Report: TAB Report
Function: Test, Adjust, & Balance
Date: 02/19/2025
Completed By: National TAB

PROJECT
02-17-25 FREDDY'S DOUGLAS, GA

Table Of Contents

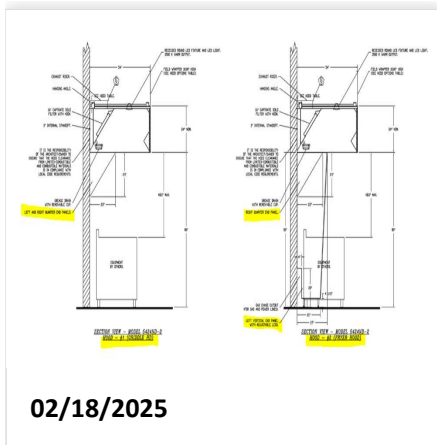
Issue Name : DOAS (Unit 2) Duct Leakage
Description : The kitchen DOAS unit is leaking significantly at the supply drop. The leakage can be felt by hand on the side of the drop. Airflow is currently ~1900CFM out of 2800CFM design (68%) as-is. The fan speed is set to the maximum allowed frequency on the controller. (50Hz).
Created By : National TAB **Assigned To :** National TAB - Dan Hertenstein
Status : Open
Priority : Urgent **Asset Tag :**
Originated Date : 02/18/2025 - Stephen Tassinaro - National TAB
